Title - Sujet CCG Modular Building Construction	
Solicitation No. - N° de l'invitation F1700-195552/A	Amendment No. - N° modif. 005
Client Reference No. - N° de référence du client F1700-195552	Date 2019-08-21
GETS Reference No. - N° de référence de SEAG PW-\$PWY-031-8623	
File No. - N° de dossier PWY-9-42034 (031)	CCC No./N° CCC - FMS No./N° VME
Solicitation Closes - L'invitation prend fin at - à 02:00 PM on - le 2019-08-23	
F.O.B. - F.A.B. Plant-Usine: <input type="checkbox"/> Destination: <input checked="" type="checkbox"/> Other-Autre: <input type="checkbox"/>	
Address Enquiries to: - Adresser toutes questions à: Leung, Janie	Buyer Id - Id de l'acheteur pwy031
Telephone No. - N° de téléphone (778) 919-3273 ()	FAX No. - N° de FAX (604) 775-6633
Destination - of Goods, Services, and Construction: Destination - des biens, services et construction: DFO - Hartley Bay, BC

Amendment 005

This amendment issued to publish Addendum #4

Project name/Title de projet
HARTLEY BAY, B.C.
HARTLEY BAY
SAR STATION

Project No./No. de projet: 2017566
Sheet/Feuille: E1.01
REV 4 OF 4

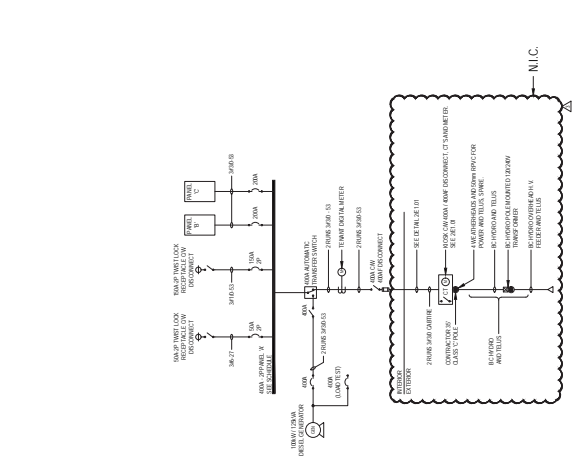
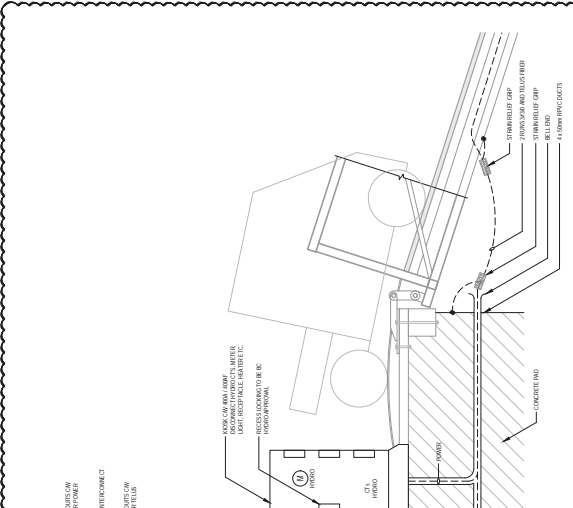
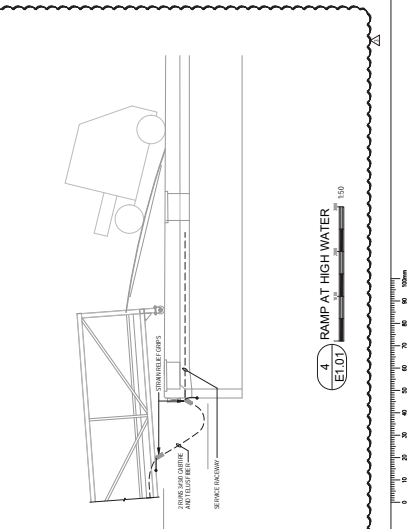
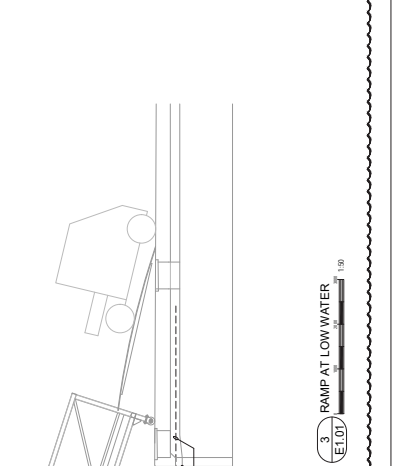
Question: My electrical sub has noted that the electrical drawings indicate that there is work to be done in Hartley Bay. It is our understanding that the concrete float and SAR station are to be delivered to Steveston and that there is no work taking place in Hartley Bay itself. Please clarify.

1. Drawing E1.00, E1.01.

See items noted as Not in Contract (NIC)

Response: No work is to take place in Hartley Bay.

Electrical hookup to shore shown and any shore work as shown on E1.01 are not part of contract. Power and communications service from shore to termination point in building not part of this contract.

However, temporary power and communications hookup for the purpose of testing and commissioning is to be provided as per Spec section 01 11 55.
